Access Compliance Report Public Rights-of-Way (Pedestrian Signals)

Intersection ID: N/A	Main Street:	Cross Street: N/A	Location: N/A
ADA ID: ECC0EA63E697	Signal Type: Two Push Buttons-Non APS	Overall Compliance: No	Severity Score: BTN 1:N/A BTN 2: N/A No BTN: N/A
Codes/Mitigation Info/Possible Solution		Field Measurements/Component Compliance

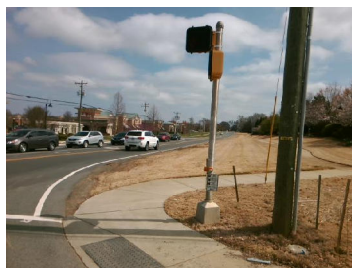
PROW/ADA: TMUTCD 4e.08, R404.7.3, R404.7.2

N/A	B 1 FWD Approach Width (in)	N/A	N/A	B 2 FWD Approach Width (in)	N/A
N/A	B 1 FWD Approach Obstruction?	Yes	N/A	B 2 FWD Approach Obstruction?	Yes
N/A	B 1 FWD Approach Obstruction Dist (in)	2.0	N/A	B 2 FWD Approach ObstructionDist (in)	2.0
N/A	B 1 PARA Approach?	Yes	N/A	B 2 PARA Approach?	Yes
N/A	B 1 PARA Approach Constrained?	Yes	N/A	B 2 PARA Approach Constrained?	Yes
No	B 1 PARA Approach Reach (in)	16.0	No	B 2 PARA Approach Reach (in)	16.0
No	B 1 PARA Approach Width (in)	48.0	No	B 2 PARA Approach Width (in)	48.0
N/A	B 1 PARA Approach Obstruction?	Yes	N/A	B 2 PARA Approach Obstruction?	Yes
N/A	B 1 PARA Approach Obstruction Dist (in)	2.0	N/A	B 2 PARA Approach ObstructionDist (in)	3.0
Yes	B 1 Clear Floor Space Slope (%)	1.2	Yes	B 2 Clear Floor Space Slope (%)	1.3
Yes	B 1 Clear Floor Space XSlope (%)	1.6	Yes	B 2 Clear Floor Space XSlope (%)	1.6
N/A	B 1 PAR Slope (%)	N/A	N/A	B 2 PAR Slope (%)	N/A
Yes	B 1 Height (in)	39.0	Yes	B 2 Height (in)	39.0

N/A	B 1 Clear Xing Direction?	Yes	N/A	B 2 Clear Xing Direction?	Yes
	B 1 Crossing Direction	To NW		B 2 Crossing Direction	To W
Yes	B 1 DistanceTo XWalk (in)	0.0	Yes	B 2 DistanceTo XWalk (in)	27.0
No	B 1 DistanceTo Curb (in)	81.0	No	B 2 DistanceTo Curb (in)	81.0
Yes	B 1 Diameter (in)	2.0	Yes	B 2 Diameter (in)	2.0

Possible Solutions: Replace Signal Push Button With APS Button on New Post. Remove & Relocate Sign.
